## 2.12 Station Electrical Systems

The information in this section of the reference ABWR DCD, including all subsections, figures and tables, is incorporated by reference with the following departures.

STD DEP T1 2.12-2 (Figure 2.12.15)

Figure 2.12.15 Instrument and Control Power Supply

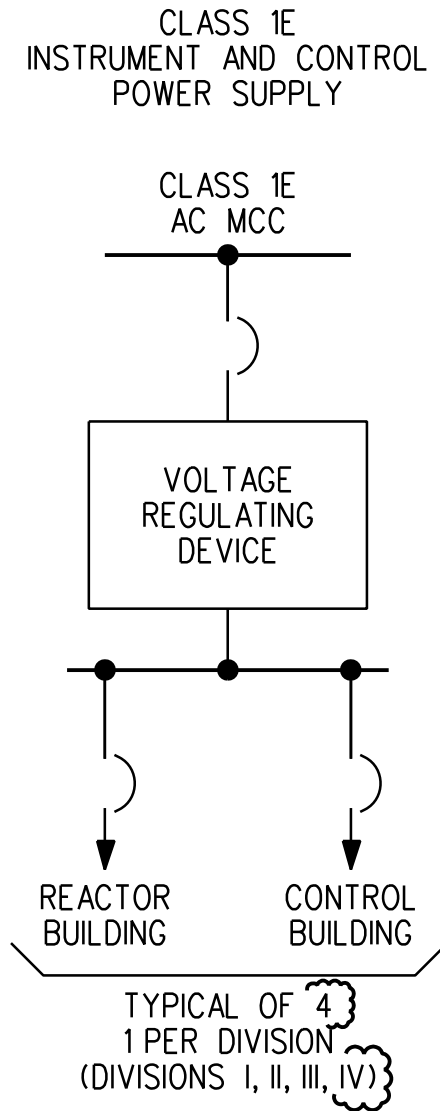
STD DEP T1 2.12-2

*The Class 1E Instrument and Control Power Supply consists of ~~three~~ four divisions (Division I, II, ~~and III, and IV~~) of interruptible power supplies with their respective distribution panels. Each Class 1E power supply provides interruptible, regulated AC power to Class 1E circuits which do not require continuity of power during a loss of preferred power (LOPP).*
